ADDENDUM NO. 2

**New Premium 63 Site Loop Campground
St. Francois State Park
Bonne Terre, Missouri
PROJECT NO.: X2317-01**

August 29, 2025

SHEET NUMBER:

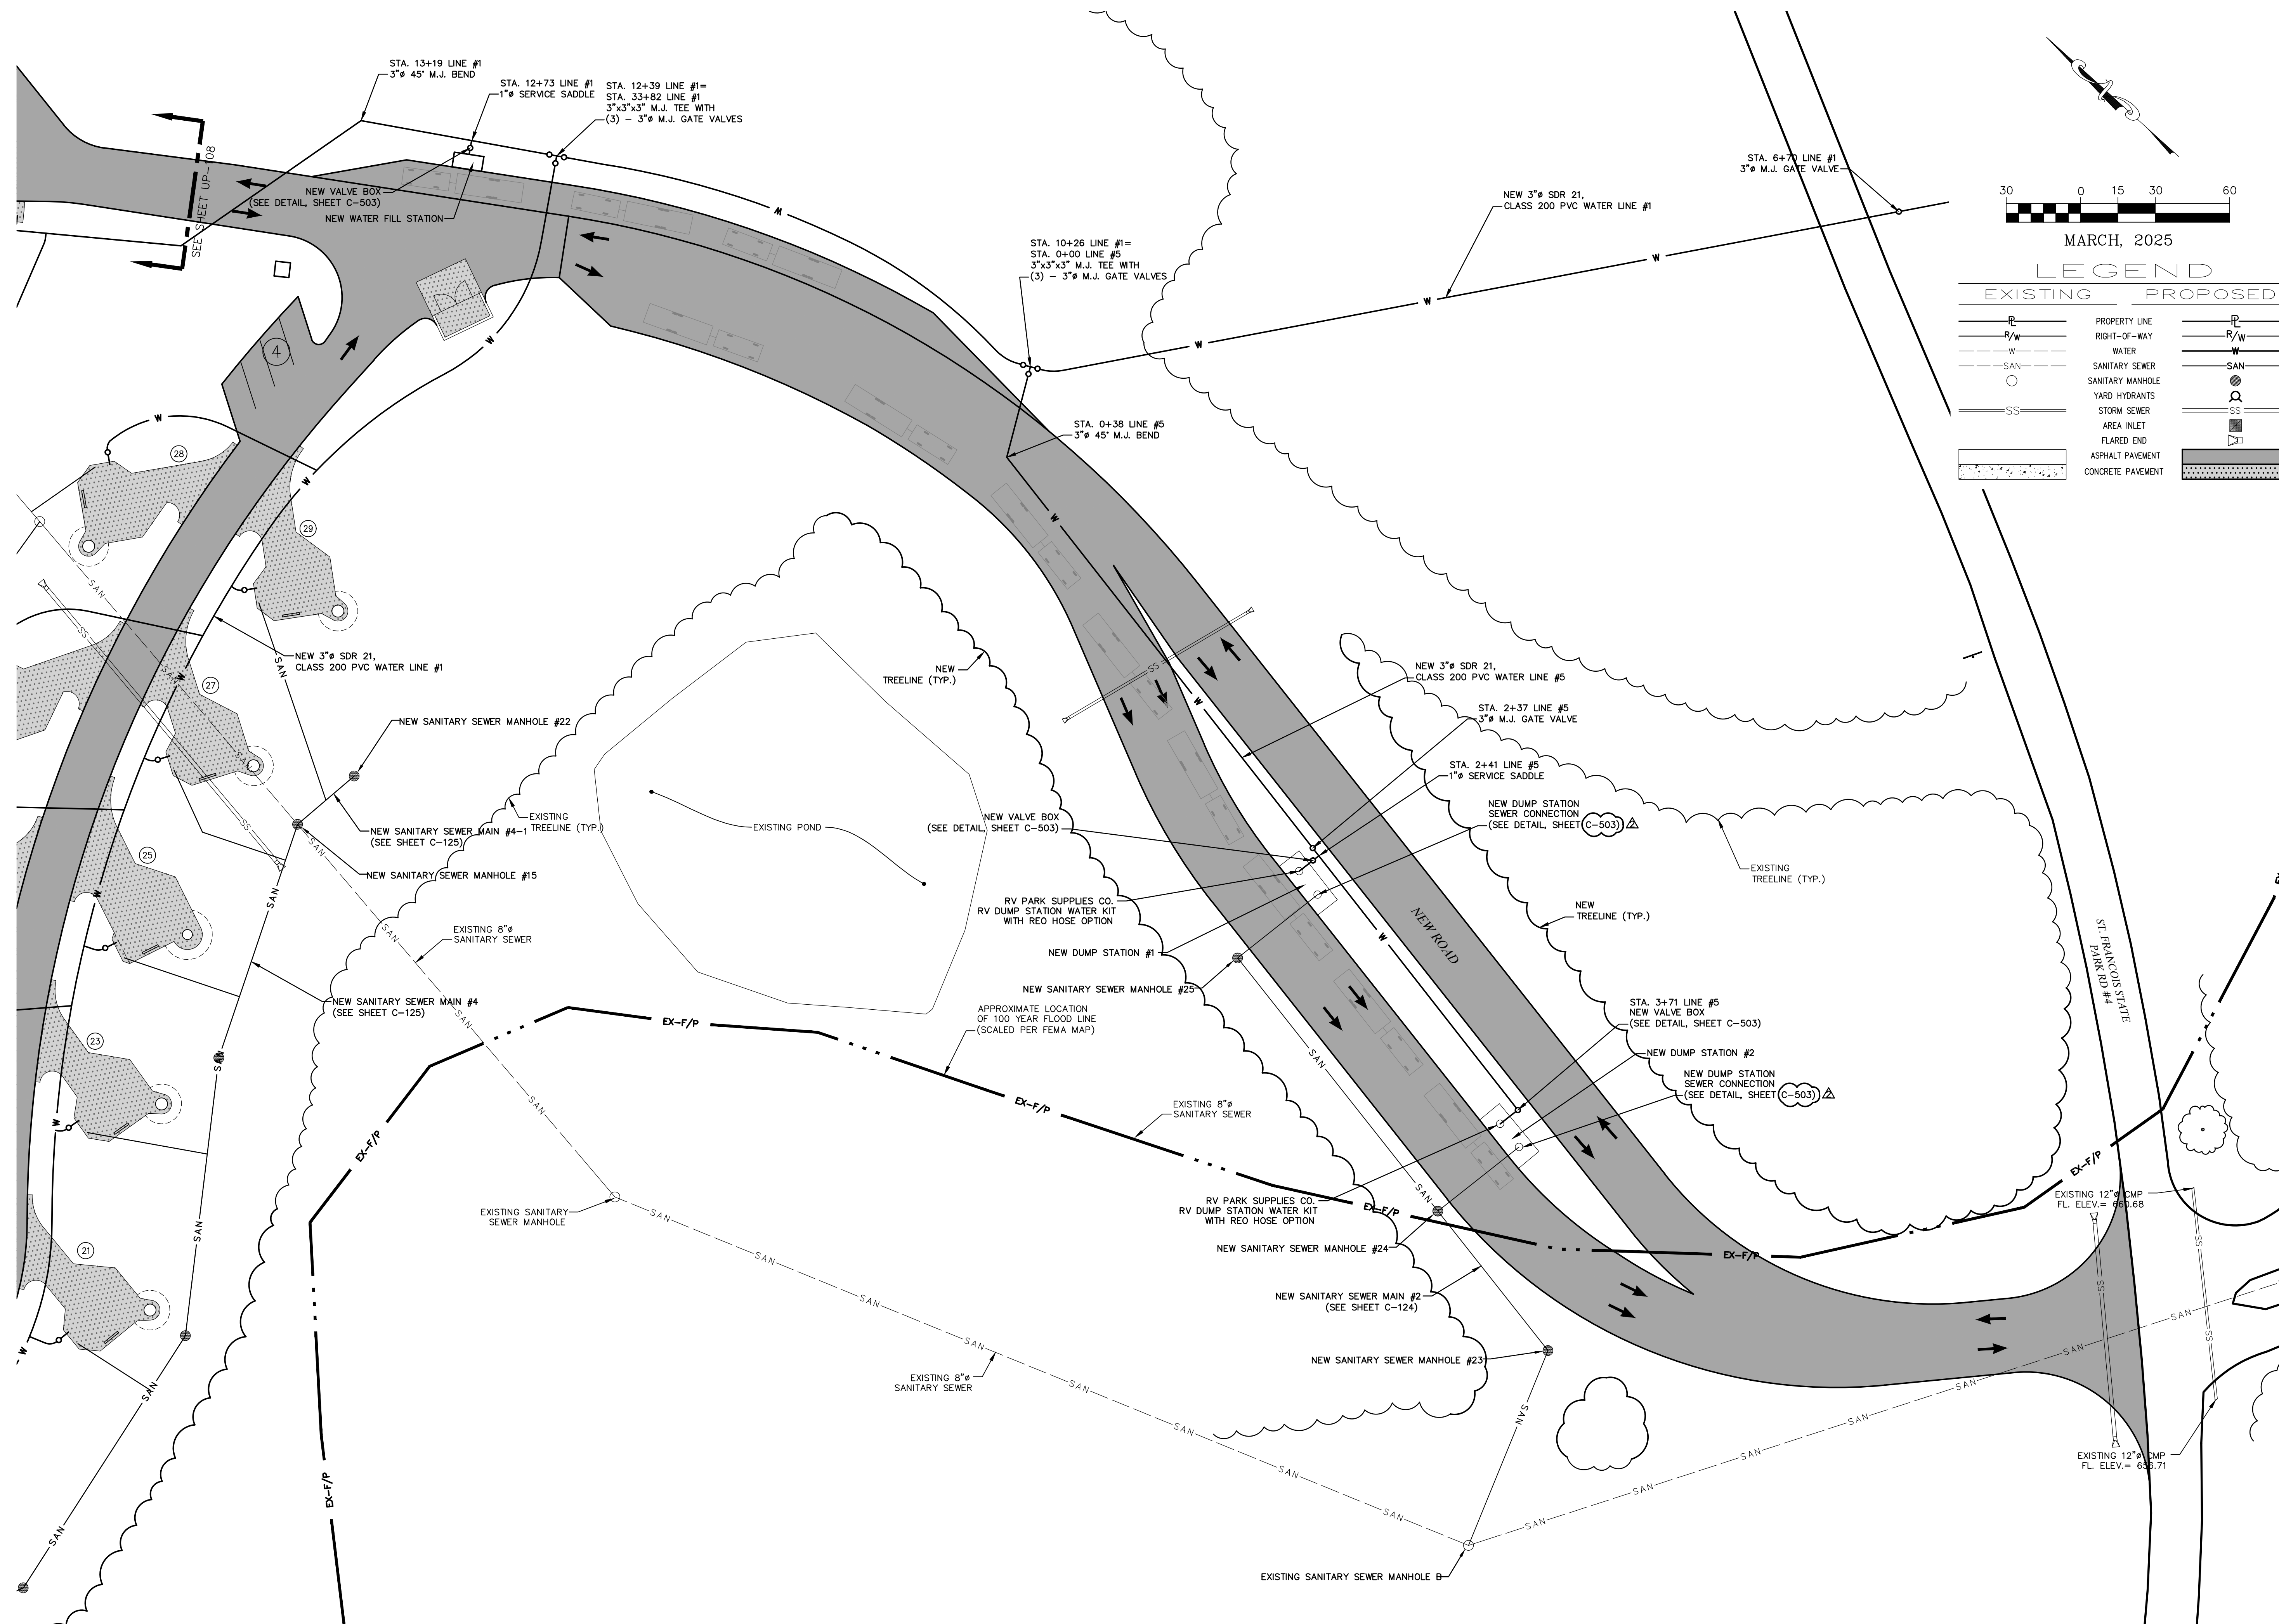
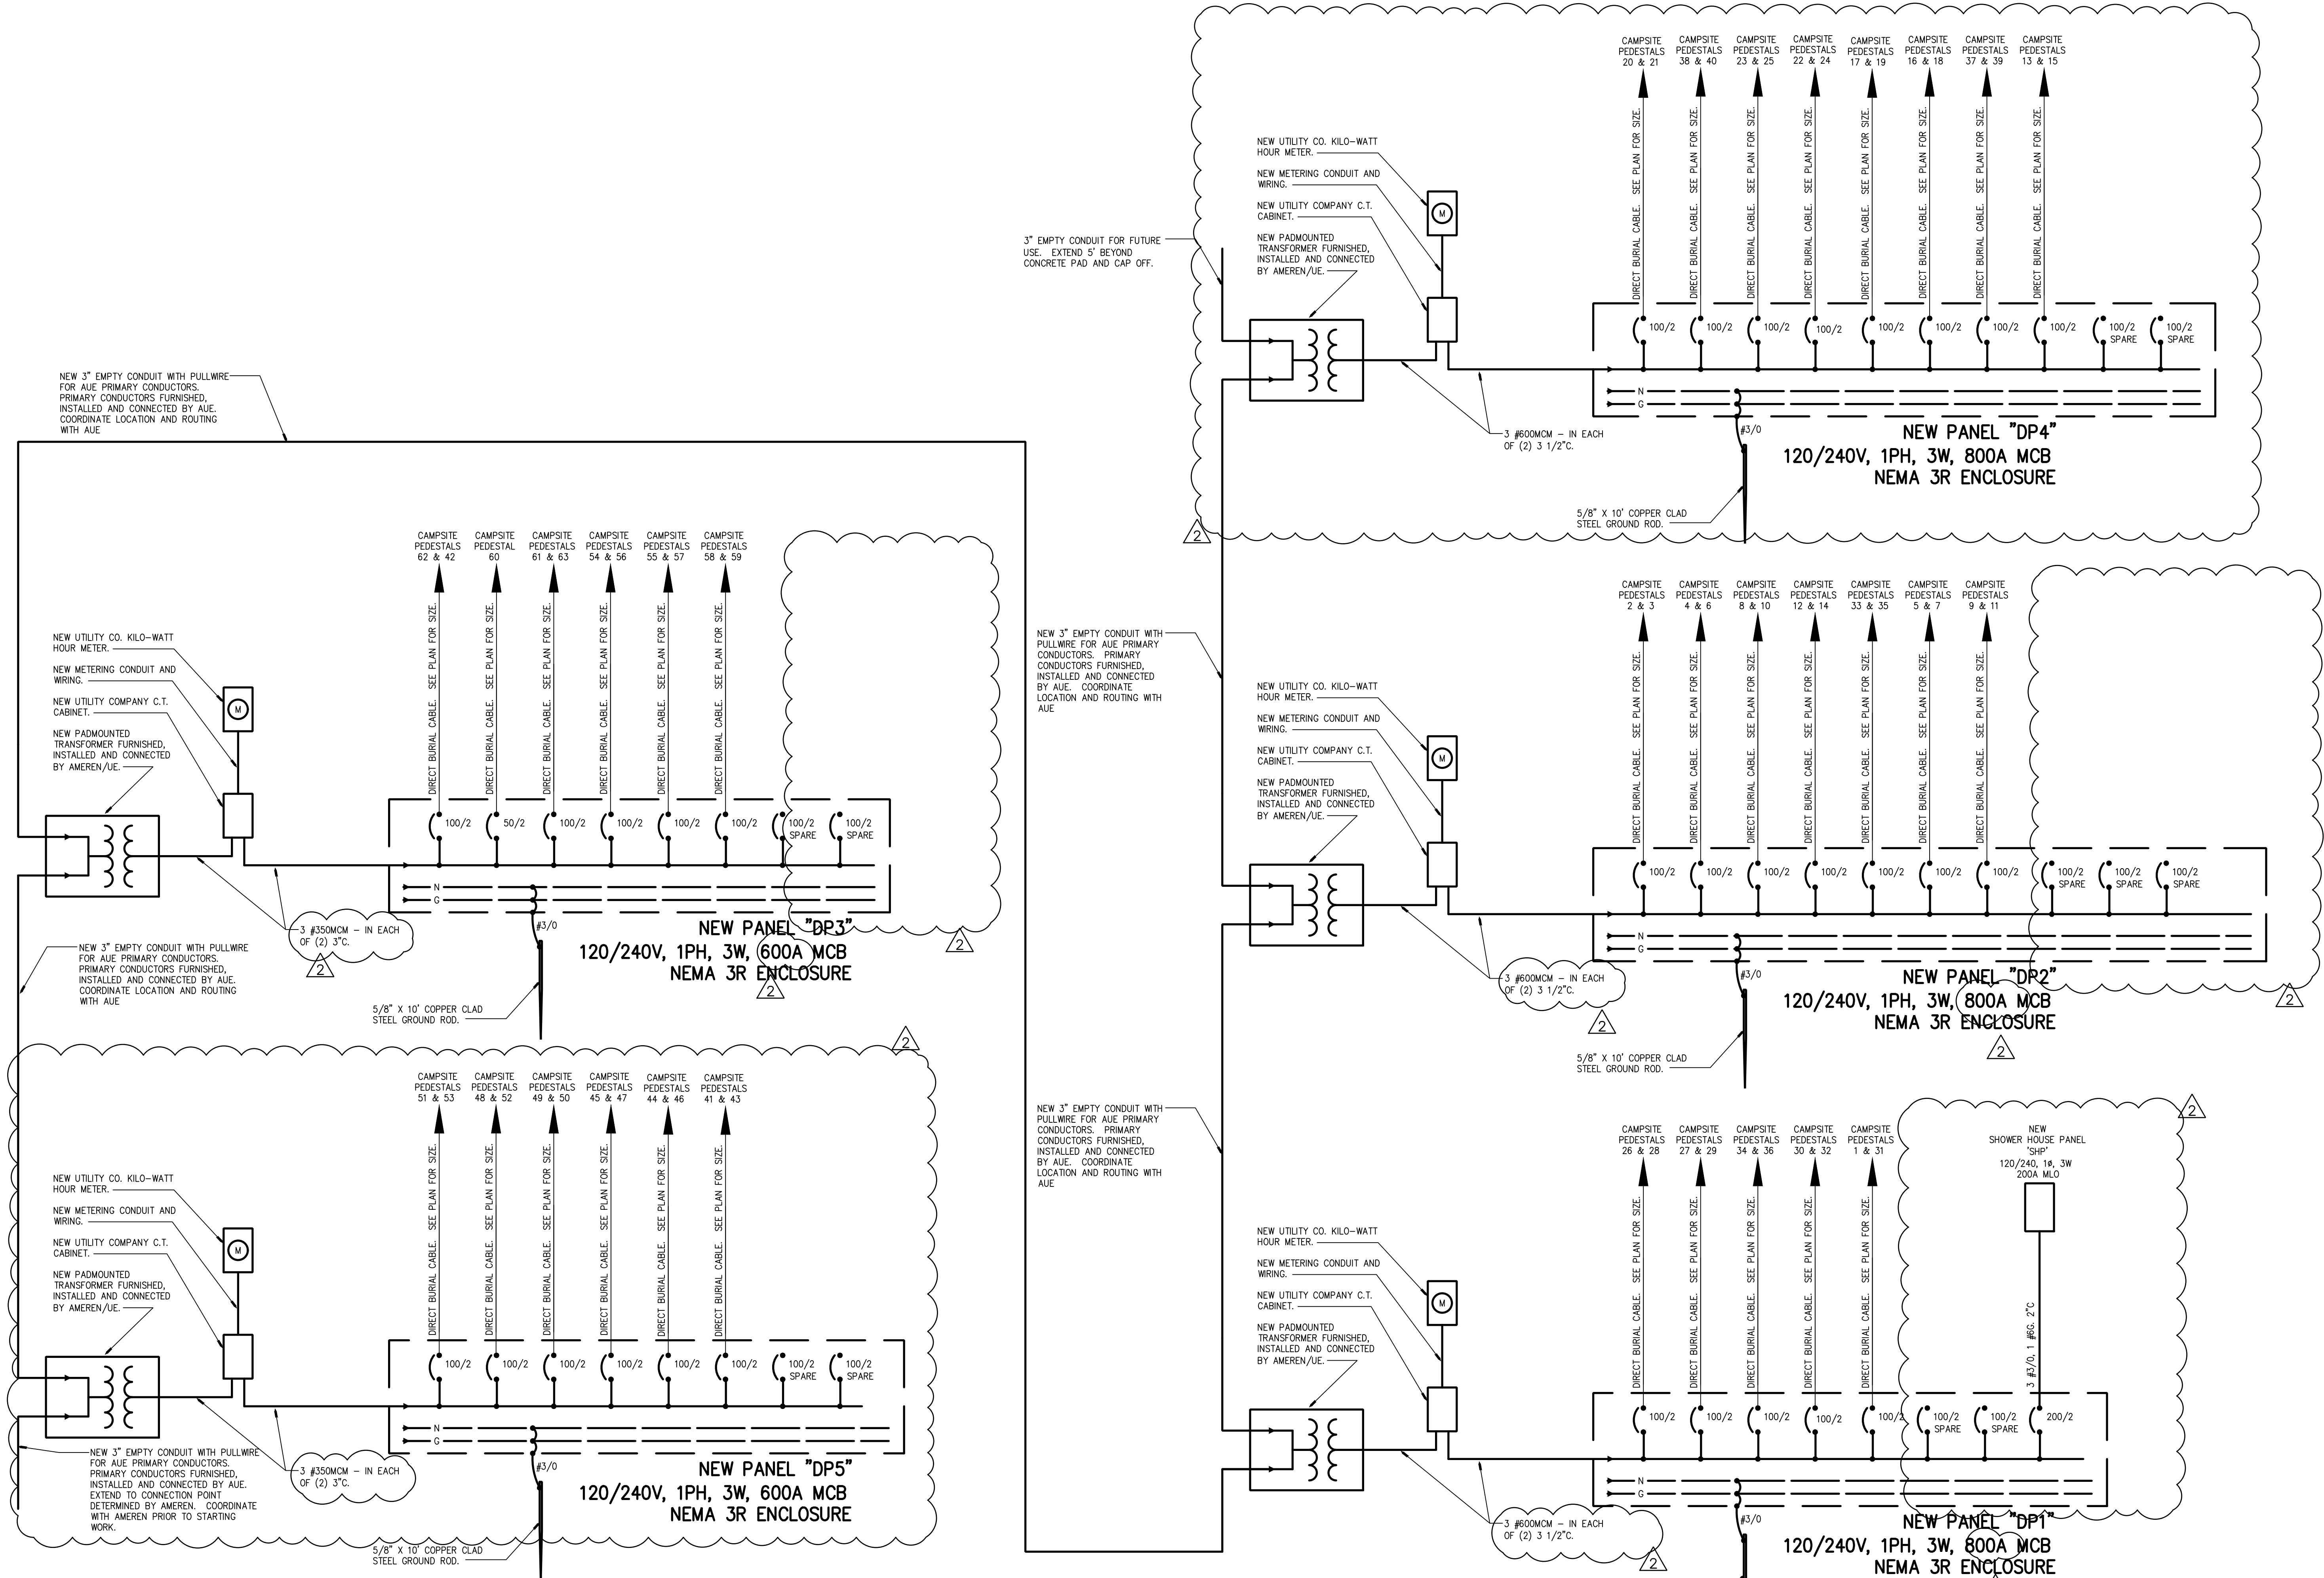
1. Added new frost proof hydrant and gate valve at end of 2-inch water line.
2. Revised electrical conduit layout and transformer locations.
3. Added tree removal for water line connection.
4. Added boring for water line under roadway.
5. Added pavement repair for water line in campground.

SHEET TITLE:
**ELECTRICAL
DETAILS**

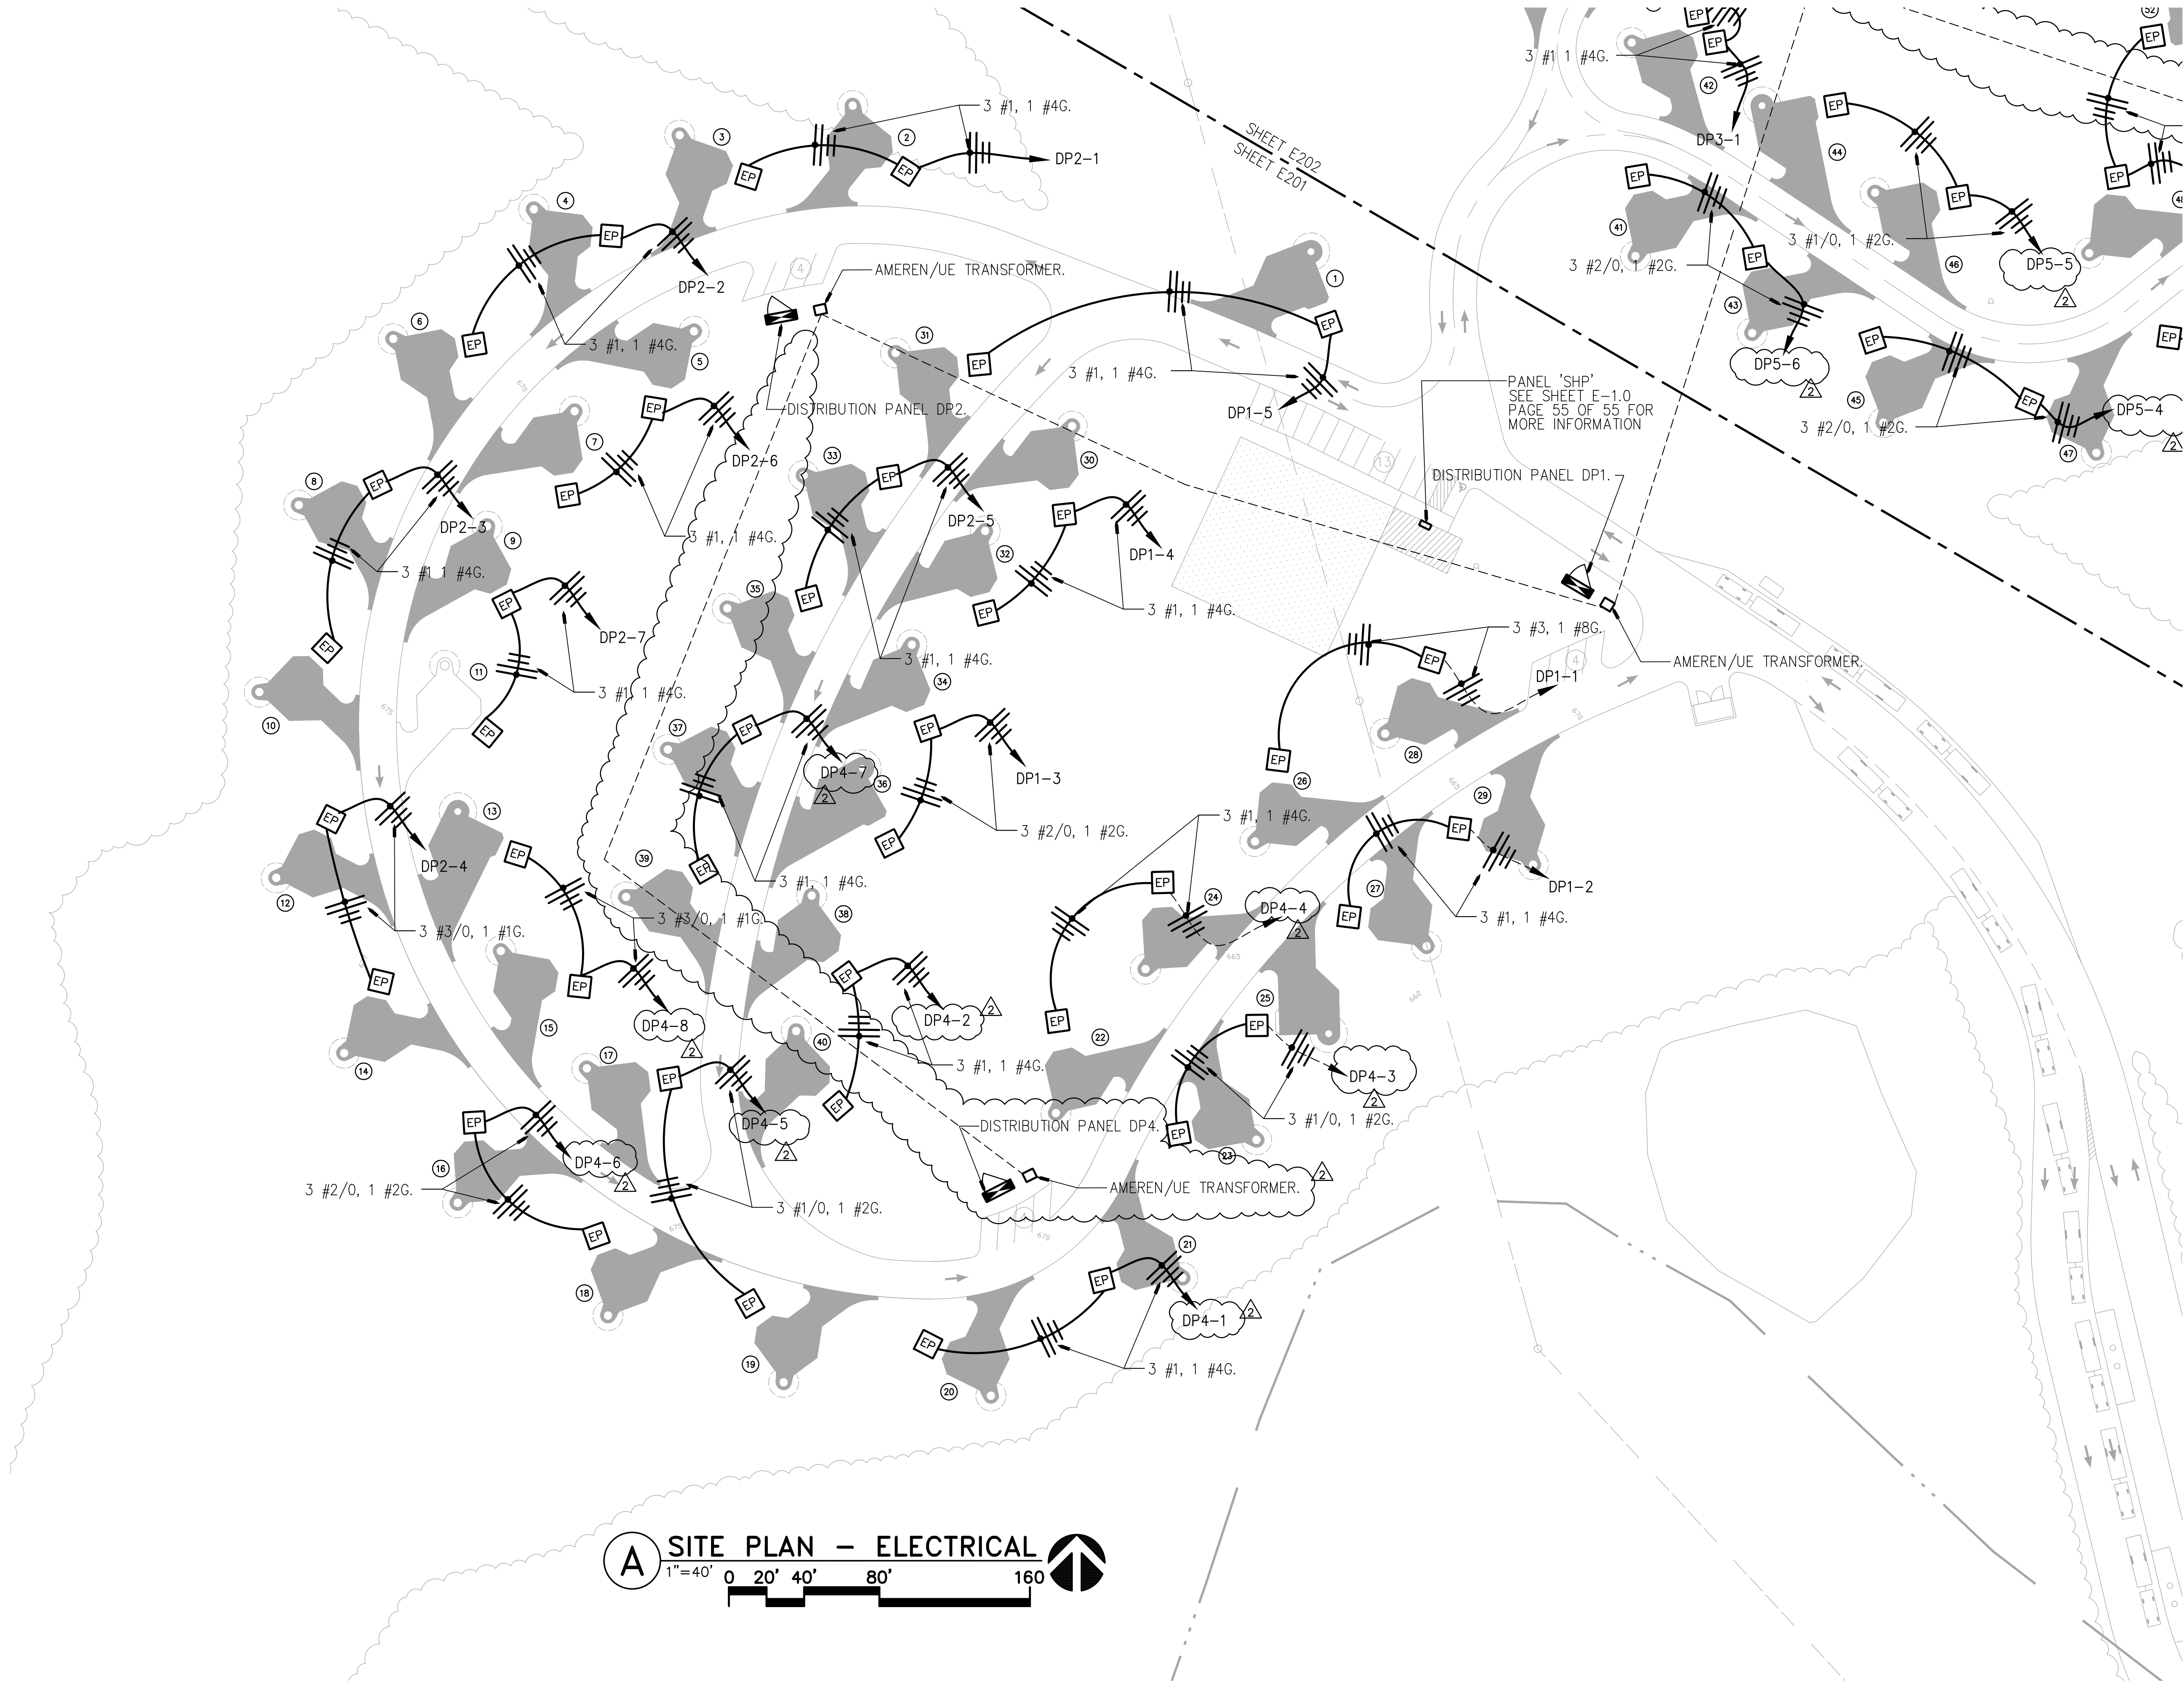
1. Changes services from (3) 1200A services to (2) 600A services and (3) 800A services to comply with Ameren.
2. Added additional transformers and distribution panels DP4 and DP5.
3. Moved circuiting from panels DP1 and DP2 to new panel DP4.
4. Moved circuiting from panel DP3 to new panel DP5.
